Access Compliance Report

Public Rights-of-Way

(Curb Ramps)

Intersection ID: 28680	Main Street: OAK_LEIGH_DR	Cross Street: WEXFORD_MEADOWS_LN	Location:	N
ADA ID: B370E24F08E9	Ramp Type: Perp	Initial Pass/Fail: Fail	Overall Compliance: No	Severity Score: 25

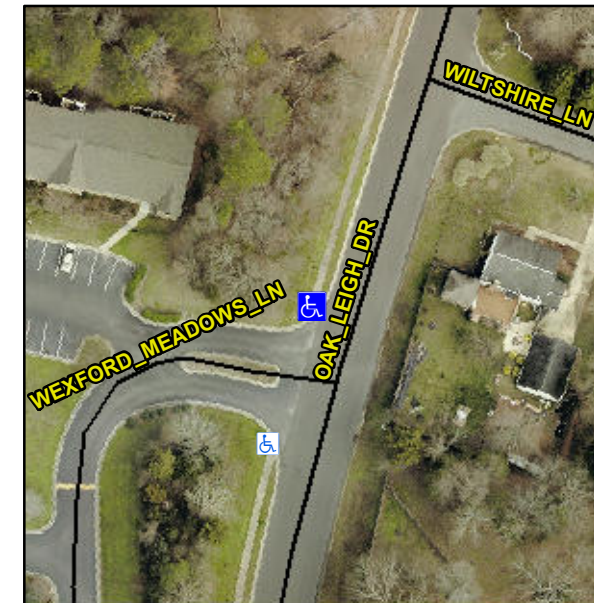
R304.2.2

Compliance	Description	Data	Compliance	Description	Data
N/A	Ramp Length (in)	53.0	No	Ramp Slope (%)	15.5
Yes	Ramp Width (in)	48.0	Yes	Ramp XSlope (%)	1.7
N/A	Flare Type LT	N/A	N/A	Flare Type RT	N/A
N/A	Flare Slope LT (%)	N/A	N/A	Flare Slope RT (%)	N/A
N/A	Flare Traversable LT?	N/A	N/A	Flare Traversable RT?	N/A
N/A	Landing Length (in)	N/A	N/A	DWS Provided?	N/A
N/A	Landing Width (in)	N/A	N/A	DWS Contrast?	N/A
N/A	Landing Slope (%)	N/A	N/A	DWS Length (in)	N/A
N/A	Landing X Slope (%)	N/A	N/A	DWS Full Width?	N/A
N/A	Landing Curb? (Y/N)	N/A	N/A	DWS Offset (in)	N/A
N/A	Shared Landing?	N/A			
N/A	Gutter Ponding?	N/A	N/A	Gutter Slope (%)	N/A
N/A	Gutter Lip Ht (in)	N/A	N/A	Gutter X Slope (%)	N/A
N/A	Painted X Walk1?	No	N/A	Painted X Walk2?	N/A
	X Walk 1 Direction	To SW		X Walk 2 Direction	N/A
N/A	X Walk 1 Width (in)	N/A	N/A	X Walk 2 Width (in)	N/A
	X Walk 1 Slope (%)	0.8		X Walk 2 Slope (%)	N/A
	X Walk 1 X Slope (%)	5.0		X Walk 2 X Slope (%)	N/A

Remove & Replace Entire Ramp.
